<b>ADDENDUM TO THE BID DOCUMENTS</b>		Page: 1	Total Pages: 33
Addendum No: # 2		Date this Addendum Issued: <b>September 13, 2022</b>	
<u>Issuing Office:</u> Matanuska-Susitna Borough School District (MSBSD) Purchasing Department 690 Cope Industrial Way Palmer, Alaska 99645 Phone: (907) 861-5120 Facsimile: (907) 861-5184		<u>Previous Addenda Issued:</u> One <u>1</u> <u>September 2, 2022</u> _____ _____ _____ _____ _____	
<u>Return Acknowledgment To:</u> <b>Issuing Department</b>  <u>Bid Title:</u> <b>New Building at Academy Charter School</b>  <u>Bid No:</u> <b>B23-01</b>		<u>Date and Hour of Bid Due Date:</u> <del>September 9, 2022 at 2:00 P.M.</del> <b>September 19, 2022 at 2:00 P.M.</b>  <u>As Advertised (Frontiersman):</u> <b>August 19 and 21, 2022</b>  <u>As Advertised (ADN):</u> <b>August 18 and 21, 2022</b>	
<p><b>The following corrections, changes, additions, deletions, revisions, and/or clarifications are hereby made a part of the contract documents. In case of conflicts between this addendum and previously issued documents, this addendum shall take precedence. The bidder must acknowledge receipt of this addendum in the space provided on Appendix #1. Failure to do so may su

SHEET  
C6.0

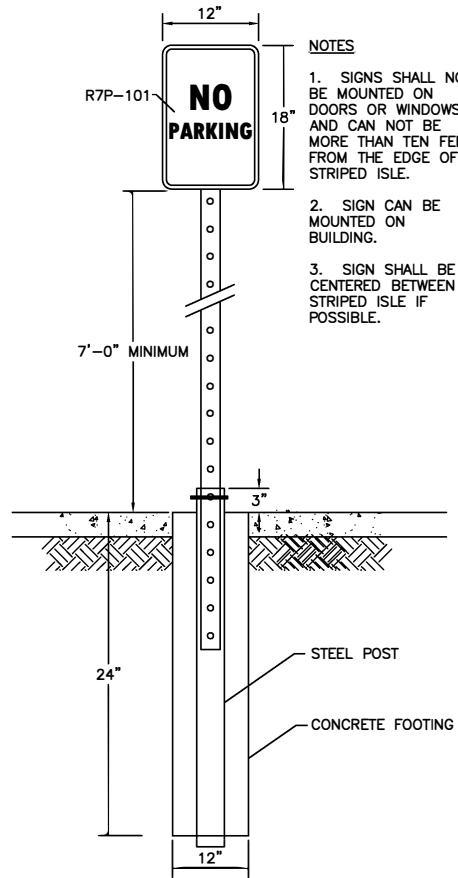
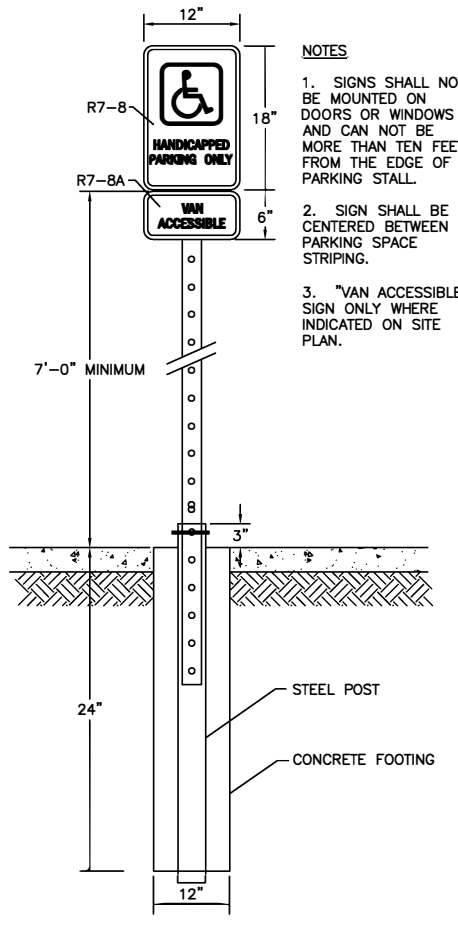
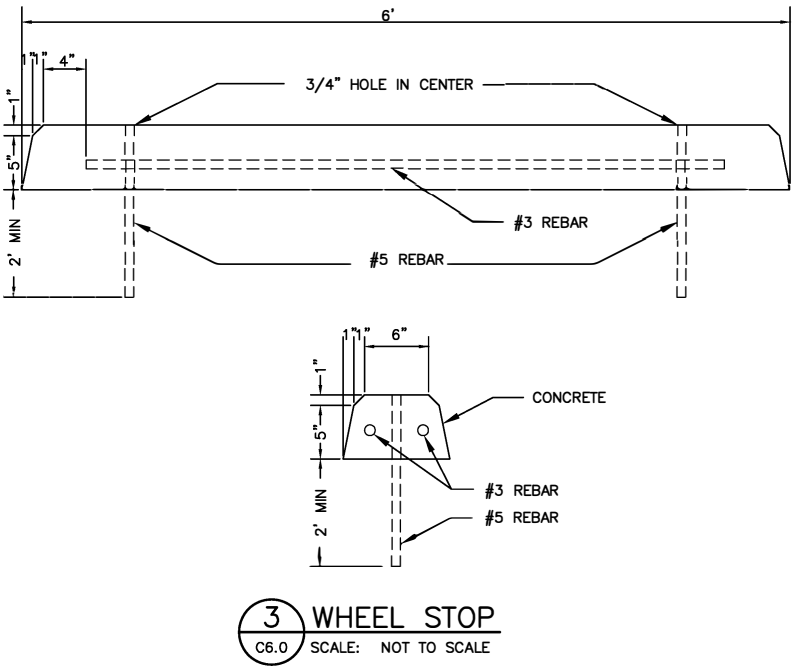
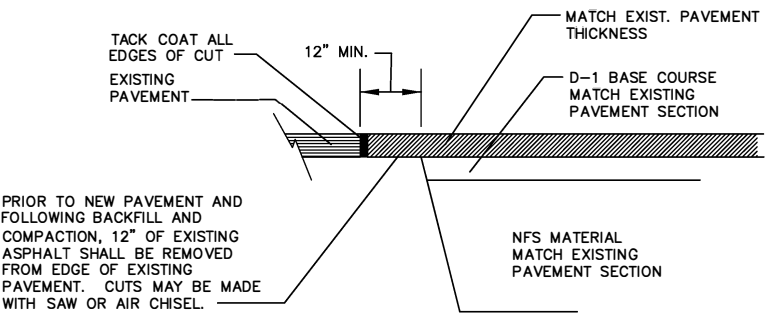
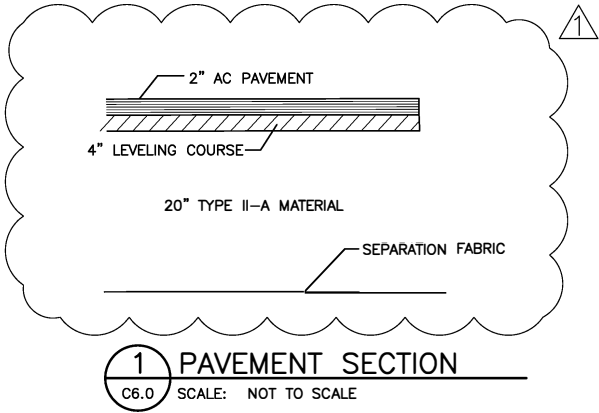
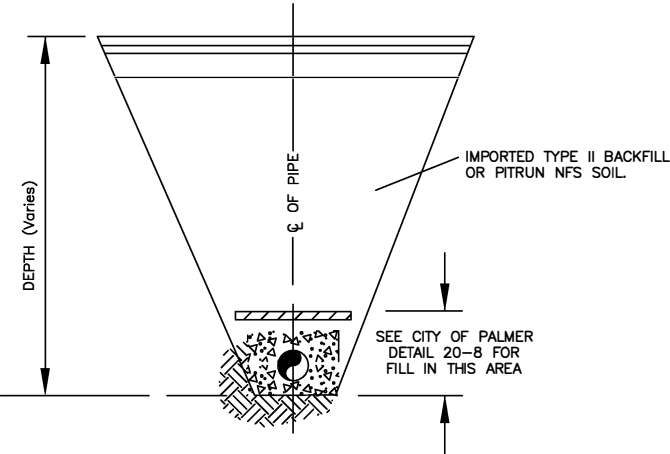
24. Q: On plans sheet C6 Drawing #1 Shows 2" Asphalt and 3" Leveling course, 8" Type II-A, and 30" Type II Materials as NIC. Is this correct?

A: Please review Appendix 11, Updated Pavement Section for clarification.

BY	DATE	REVISIONS
△	9/7/22	INFORMATION ADDED FROM SOILS REPORT
